**Response to Mr Mike Taylor's Document entitled *Isles Quarry Contamination Concerns* submitted to Jennifer Wilson of the Environment Agency by email on 23.08.2014, prepared by *Geo-Environmental Investigations Ltd***

The queries, points and allegations raised by Mr Taylor in his recent submission to the EA will be addressed in their order of appearance in that document.

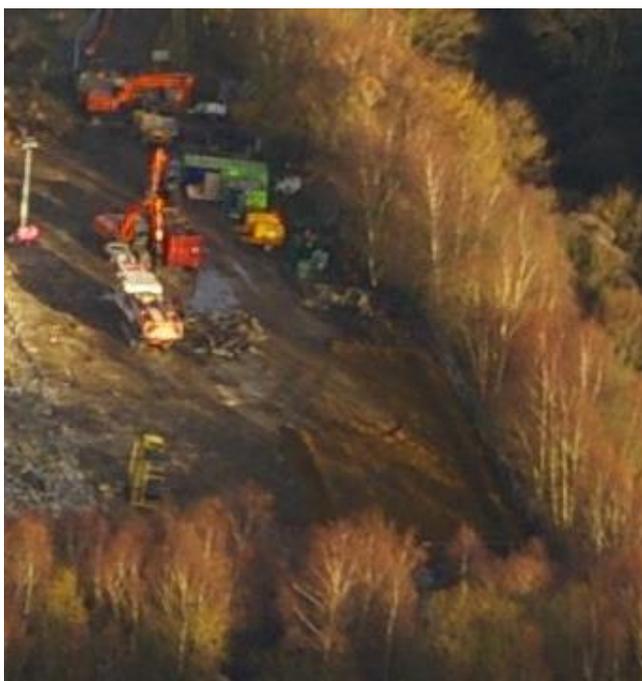
Text between the photos: “Our aerial picture on 8<sup>th</sup> December shows the bund under construction. Crest reasoned that our aerial picture showed the bund in use, but with one end left open to allow material to be delivered”.

Text below aerial photograph, first two sentences: "However, the bund is supposed to have a plastic liner, and as our picture below of the bund on 28 March shows that liner is black, and overlaps the bund walls to create a >pond<, and this is clearly not in position on 8<sup>th</sup> December. The black liner should be clearly visible around the perimeter above if it was installed, and across the entire base, even if we accept the premise that the bund wall will not be completed whilst the bulk is being filled".

Yet again, Mr Taylor’s aerial photo is not dated, and therefore does not stand up to scrutiny in arguments about what was done when. But more to the point, Mr Taylor has misinterpreted his own aerial photograph: what he assumes to be the bund under construction is not the bund at all. The contaminated storage bund, with the top left corner left open, is actually shown in the bottom right corner of Mr Taylor’s image, near the trees (see enlarged extract below).

The same excavator shown in the *Geo-Environmental Investigations Ltd* photo on page 4 of Mr Taylor's document is also shown in the extract of the aerial photograph reproduced above, in the top right hand corner. Despite the poor resolution of the aerial photo, this view actually demonstrates why the bund could not have been visible in the *Geo-Environmental Investigations Ltd* photo taken on 05.12.2013 used by Mr Taylor.

We agree that the black plastic liner cannot be identified on Mr Taylor's aerial photograph, but that is due to the poor resolution of the photograph, and in particular the poor contrast in the bottom right hand corner. It does not prove that this liner was not in place at the time the photo was taken, as Mr Taylor alleges: a lot of other detail is not visible. Furthermore, by the date on which Mr Taylor claims to have taken this aerial photo, the bund would not have been empty; therefore it is unlikely that much of the plastic sheeting lining the base would have been visible from any vantage point.
